DEVELOPMENT APPLICATION ASSESSMENT REPORT

Application Number:	DA2022/0843	
Responsible Officer:	Luke Zajac

Responsible Officer:	Luke Zajac
Land to be developed (Address):	Lot 12 DP 13291, 24 Delecta Avenue CLAREVILLE NSW 2107
Proposed Development:	Alterations and additions to a dwelling house including a studio and carport
Zoning:	C4 Environmental Living
Development Permissible:	Yes
Existing Use Rights:	No
Consent Authority:	Northern Beaches Council
Land and Environment Court Action:	No
Owner:	Claire Louise Cavanaugh
Applicant:	Claire Louise Cavanaugh

D1.11 Building envelope

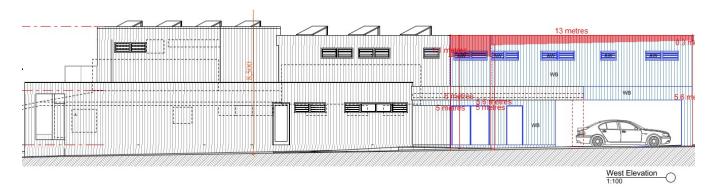
The clause stipulates that buildings are to be projected at 45 degrees from 3.5m above the existing ground level, measured from the side boundaries.

The proposed modifications breach the northern side building envelope between 0.3m and 1.1m for a length of 13m.

The proposal incorporates various design elements and varied setbacks to provide visual breaks along the elevation. Overall, the proportions of the encroaching elements are not considered to be unreasonably scaled or bulky.
